STAFF RECOMMENDATION 1501 Ferguson Avenue February 19, 2014

Application: Partial demolition; New construction—addition
District: Belmont-Hillsboro Neighborhood Conservation Zoning Overlay
Council District: 18
Map and Parcel Number: 11805001100
Applicant: Michael Ward, architect
Project Lead: Melissa Baldock, melissa.baldock@nashville.gov

<p>Description of Project: Application is to demolish existing additions and to construct an addition that is both taller and wider than the historic house.</p> <p>Recommendation Summary: Staff recommends approval of the project with the following conditions:</p> <ol style="list-style-type: none">1. The foundation for the addition be split face concrete block;2. Staff review and approve the final selections for windows, doors, and roof color; and3. The HVAC unit be placed at the rear of the addition, or on a side façade beyond the midpoint of the house. <p>With these conditions, staff finds that the addition meets Sections II.B. and III.B. of the <i>Belmont-Hillsboro Neighborhood Conservation District: Handbook and Design Guidelines</i>.</p>	<p>Attachments A: Site Plan B: Elevations</p>
---	--

AD1.0

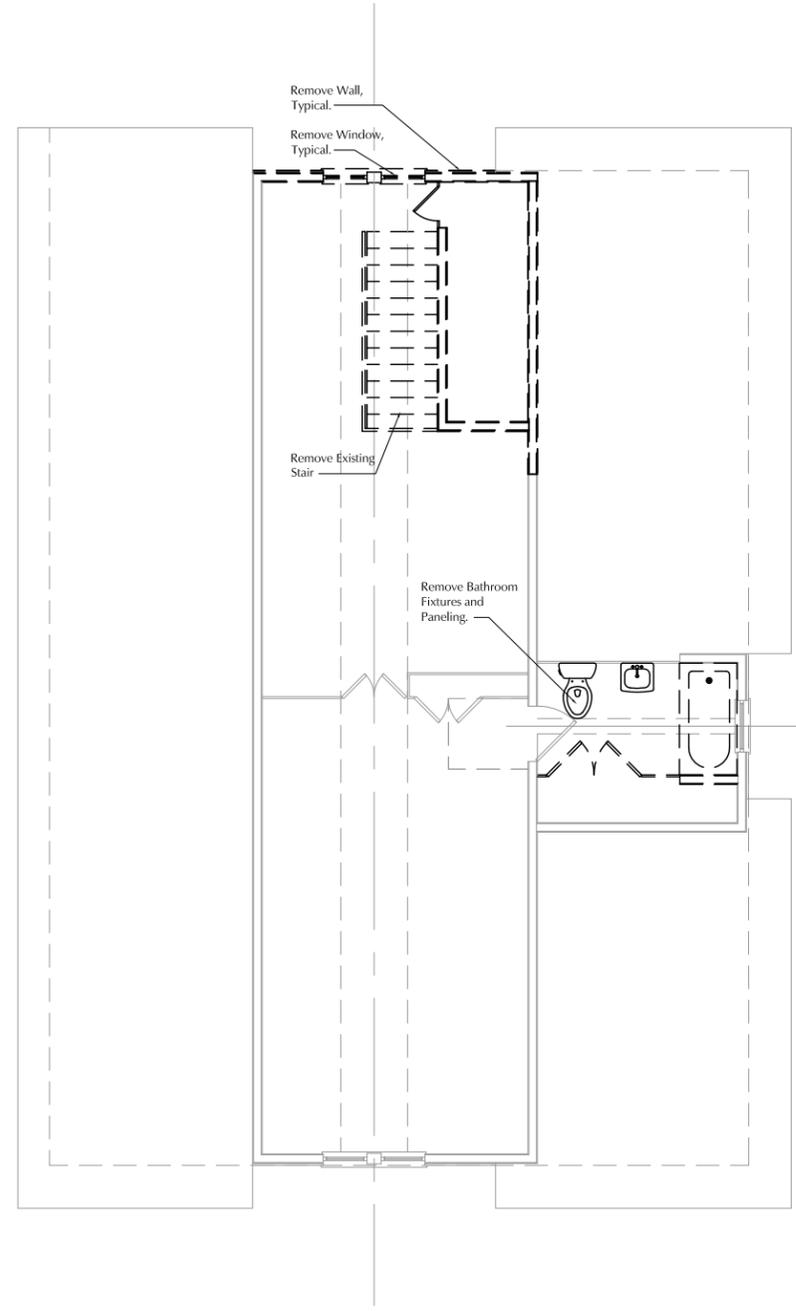
Partial Demolition: The project involves demolishing non-historic additions, altering a front/side porch enclosure, and reconfiguring window openings on the side facades.

At the front-right corner of the house is an area that was likely originally a porch that was enclosed at some point (Figure 2). The enclosure has been altered, and the applicant is proposing to reconfigure the enclosure. The new enclosure will have two foot by five foot (2' X 5') windows on the front and right side, and will include wood paneling under the windows. Staff finds that the existing enclosure is not original and does not contribute to the historic character of the house, and therefore its removal meets the design

On the left side, the applicant is proposing to remove a one-story bay and a non-historic rear addition (Figures 3, 4, 5). Although the bay may be the same bay that appears in the 1957 Sanborn map, it has a concrete block foundation that does not match the cast stone foundation for the historic house (Figure 6). Staff therefore believes that the bay is not original to the house, and it does not contribute to the house's historic character. The rear addition does not appear on the 1957 Sanborn map. It has a lower roof form from the rest of the historic house, and does not contribute to the historic character of the house. Staff finds that the removal of the side bay and the rear addition meets the design guidelines.

In addition, the applicant proposes to alter some window openings on the historic house's side facades. On the left elevation, a paired window opening just before the bay will be removed (Figure 7). Also on the left façade, a double window opening and a triple window opening will be replaced with a two foot by three foot (2'X3') window and a new double window opening (Figure 8). On the right elevation, the three window openings closest to the back of the structure will be replaced with a new triple window opening (Figure 9). Staff finds the removal of these window openings to be appropriate because they are located on the side facades and are only minimally visible due to the steep slope of the lot. In addition, the removal of these window openings will not involve removing the roof, foundation, or walls surrounding the window openings. These existing window openings are not integral to the historic character of the house, and their removal meets the design guidelines.

A2.0

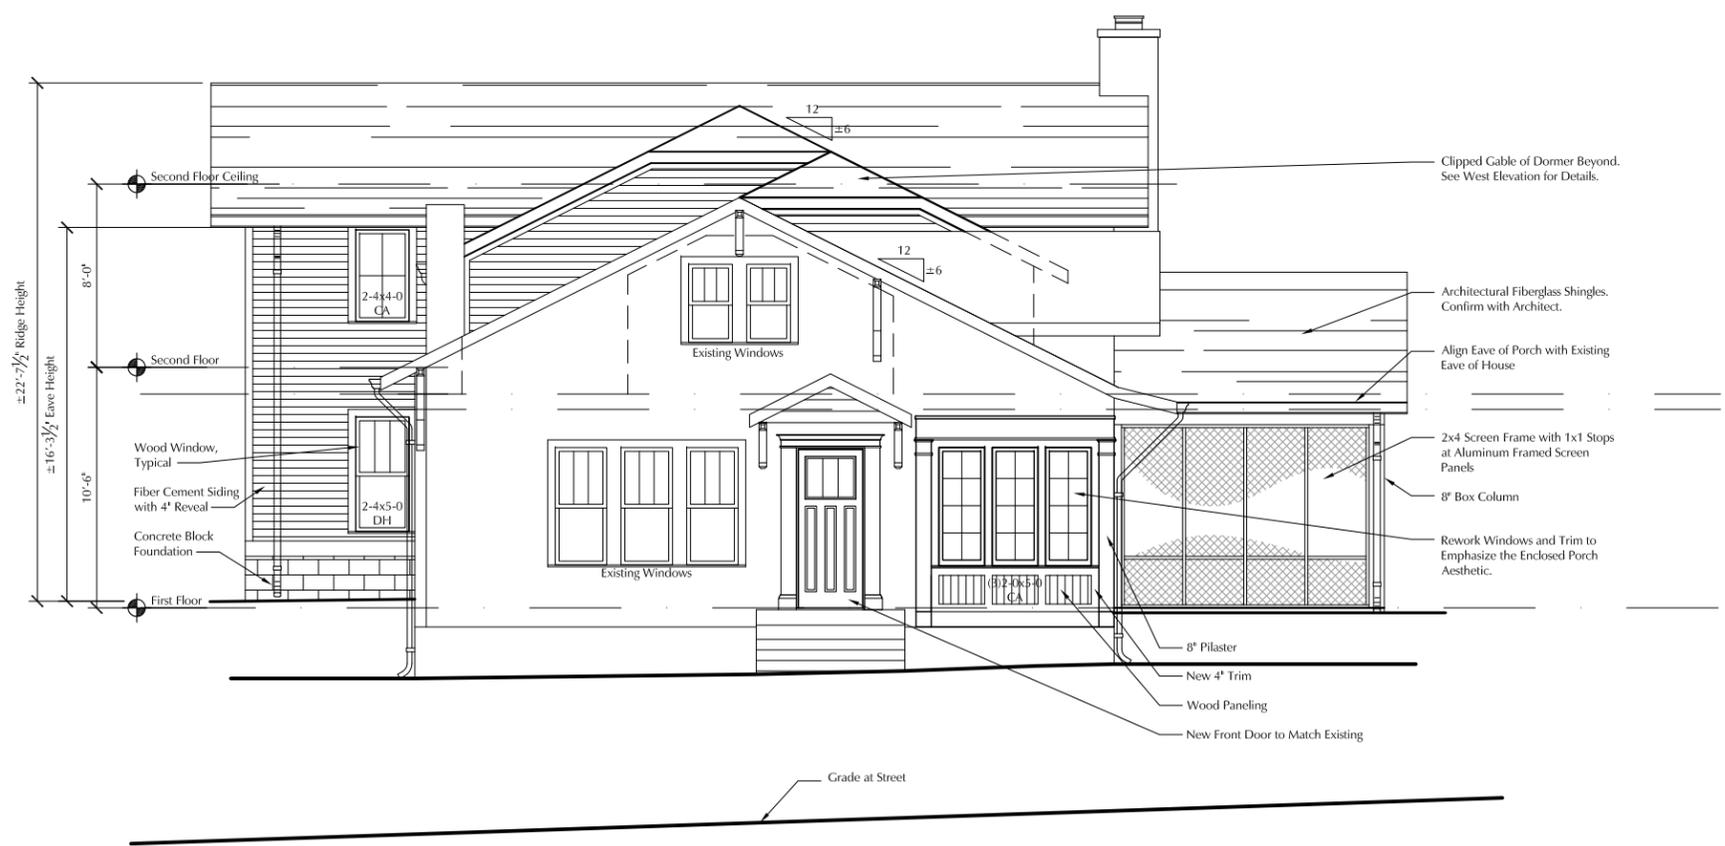
The addition will be both wider and taller than the historic structure. On the right side, the addition steps in three feet (3') from the back wall of the house, and on the left side the addition steps in one foot, ten and a half inches (1'10.5"). After a depth of approximately five feet, three inches (5'3"), the addition steps back out and expands to be wider than the historic house on both sides. On the right side, a one-story screened porch will extend eleven feet, eight inches (11'8") beyond the side wall of the house. It will be nineteen feet, eight inches (19'8") deep, with an eave height to match that of the house and a ridge height of approximately fifteen feet (15') from grade.

On the left side, the addition extends six feet, eleven inches (6'11") beyond the house's sidewall. This part of the addition will be two-stories, with an eave height of approximately sixteen feet, three inches (16'3") from grade and a ridge height of approximately twenty-two feet, seven inches (22'7") from grade. This part of the addition will be about five feet (5') taller than the historic house because of the steeply sloped grade, and will have a side gable feature. The addition will have a depth of about twenty-five feet (25'), but because of the demolition of the existing rear addition, the depth of the house will only increase by about five feet (5').

The right elevation contains a dormer at the back that is two feet (2') taller than the historic structure. This dormer is located over thirty-four feet (34') back from the front of the house and has a clipped gable form, which will reduce its visibility. Forty-seven feet, five inches (47'5") beyond the front wall of the house, the inset portion of the addition will rise another two feet (2') taller than the house's ridge, so that it is a total of four feet taller (4') than the historic house. This taller portion will have a clipped gable roof form, which will help reduce its visibility.

The design guidelines states that additions should not be wider on both sides, and should not be both taller and wider at the same time. However, because of the severity of the slope's rise and the front-gable form, it is impractical to expand the house further into the rear yard. The only practical way to expand the house is to extend out towards the sides and above the historic house. Because of the unusually steep slope of the lot, staff finds that the addition meets sections II.B.1.a., II.B.1. b., and II.B.2. of the design guidelines.
